Detailed Site Plan

Brandywine Commercial Center

DSP-20028

SUBJECT: Detailed Site Plan DSP-20028
Type 2 Tree Conservation Plan TCP2-034-2020
Brandywine Commercial Center

Figure 1: Site Plan

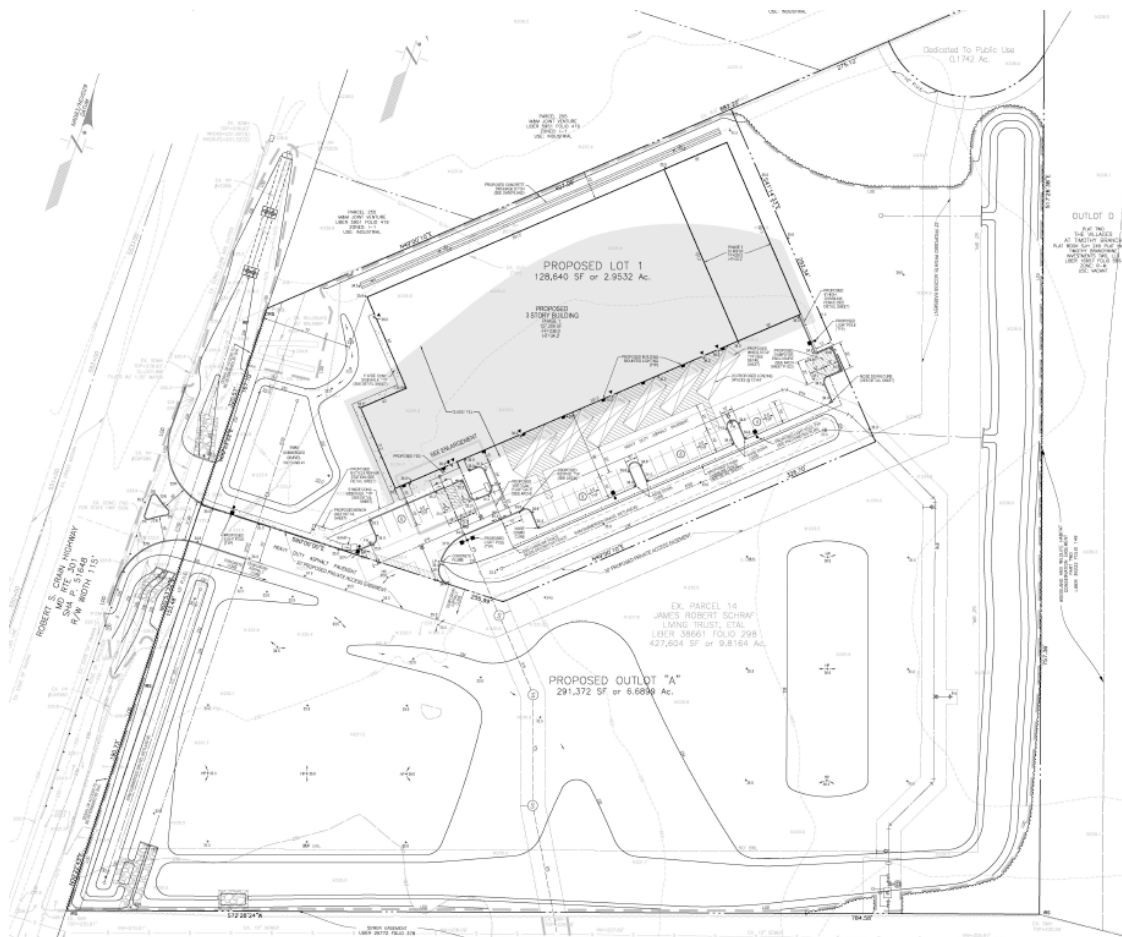
Sidewalks and crosswalks are clearly marked and provide separated routes for pedestrians and vehicles. A diagonal curb ramp connecting the crosswalk and vehicle entrance is shown on the DSP and is not acceptable, as users are directed into the center of an intersection. Staff recommends that the plans be revised to provide either a parallel or perpendicular Americans with Disabilities Act-accessible curb ramp that will direct users directly to the crosswalk and supports barrier free pathways to accommodate persons with disabilities.

outlot designation, in accordance with the PPS. In addition, the boundary area of the 0.17 acre of land to be dedicated to public use should be provided on the DSP. Conditions have been included herein for this and other minor technical corrections.

1. Prior to certification of the detailed site plan (DSP), the following revisions shall be made to the plans:
 - a. Provide bearings and distances for the 0.17 acre of land to be dedicated to public use in the northeast corner of the property.

- b. Correct all overlaps for property boundary bearings and distances to ensure that the text is legible.
 - c. Provide 5-foot-wide sidewalks on both sides of the access easement for its entirety, and along the portion of the future cul-de-sac of I-503. These sidewalks can be labeled as “to be built with future phases of development of the access easement and I-503.”

- d. Revise the diagonal curb ramp connecting the crosswalk and vehicle entrance to provide either a parallel or perpendicular Americans with Disabilities Act-accessible curb ramp that will direct users directly to the crosswalk.

- e. Provide a minimum of two inverted U-style bicycle racks, or a similar style that provides two points of contact to secure and support a parked bicycle, at a location convenient to the entrance of the building, along with an accompanying detail.
